NUCLEAR REGULATORY COMMISSION

Title: Advisory Committee on Reactor Safeguards  
Subcommittee on Materials, Metallurgy  
and Reactor Fuels

Date: Wednesday, May 22, 2013

The purpose of the meeting is to receive briefing from the NMSS staff on ISG-24 Revision 0, the use of demonstration programs as confirmation of integrity for continued storage of high burnup fuel beyond 20 years.

# Hydride Reorientation Examples

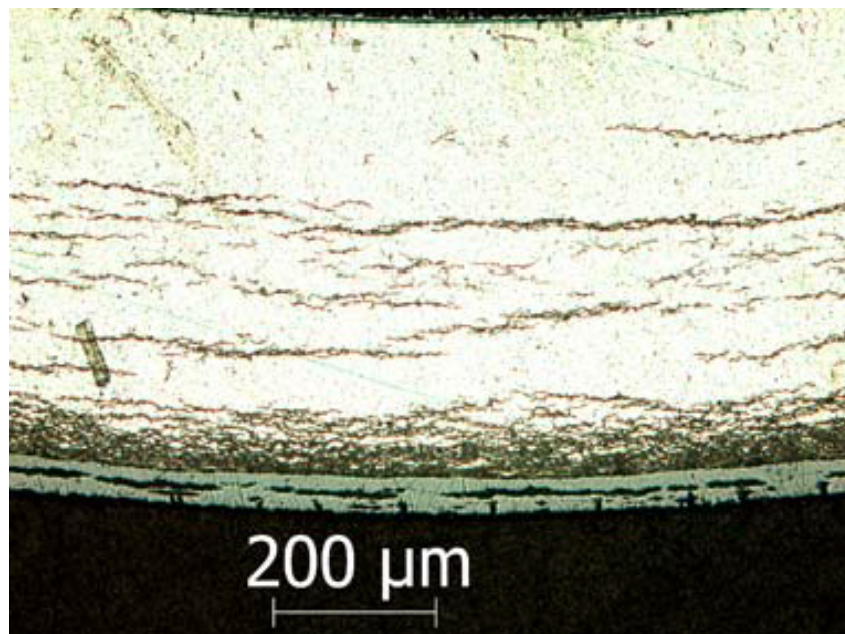
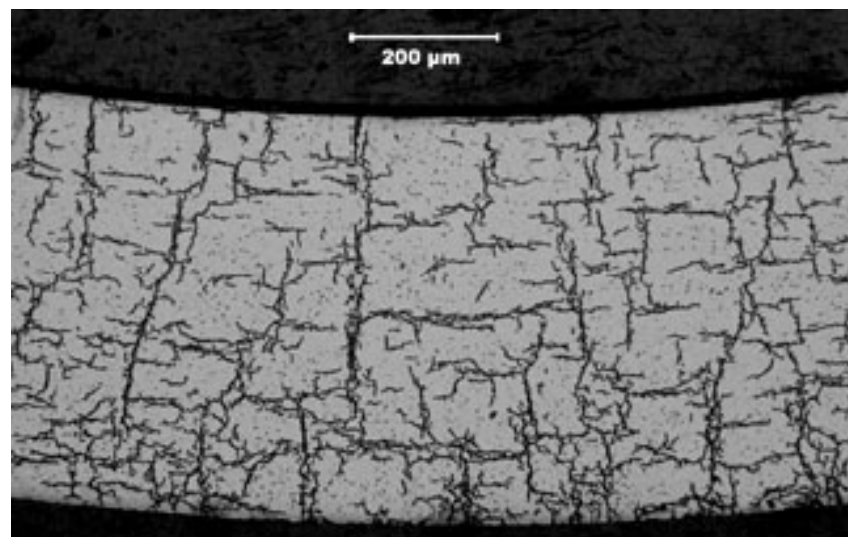
1 the picture on the right, the same material as the one  
2 on the left, that same fuel cladding would do that same  
3 thing?

5 CHAIR ARMIJO: These were both ZIRLO, with  
6 the same irradiation history?

20 CHAIR ARMIJO: Bob, before you go on, on  
21 your slide 5 there, on the right-hand image, that shows  
22 both the radial and the actual --

24 CHAIR ARMIJO: -- circumferential hydride,  
25 you mentioned that a mandril was used. Where was the

1 mandril used?

4 MR. EINZIGER: These were both ZIRLO.

10 MR. EINZIGER: These were just being used  
11 -- it's not to say that becomes -- that sample became  
12 this, it's to show, in general, this is what you get  
13 out of the reactor --

15 MR. EINZIGER: -- after you go through  
16 hydride reorientation tests, you'll get something like  
17 this.

24 MR. EINZIGER: I'd be remiss in telling you  
25 yes. I can just tell you that one is after testing and

1 one is before a test.

2 Obviously, this is in the 500 ppm hydrogen,  
3 this is only in the 190 ppm hydrogen case.

4 What you'll notice is radial hydrides.  
5 Actually, this is one of the better radial hydride cases,  
6 because you see a number of circumferential hydrides  
7 still sitting in there that are breaking them up.

2 MR. EINZIGER: The mandril was only -- did  
3 not put stress on the cladding, the mandril was only  
4 in there to limit the amount of gas in there, so that  
5 you got the right decrease of stress with temperature  
6 like you would see in a spent fuel rod.

7 It was just a hollow tube, any expansion  
8 of the rod would result in an increase in stress,  
9 depending upon --
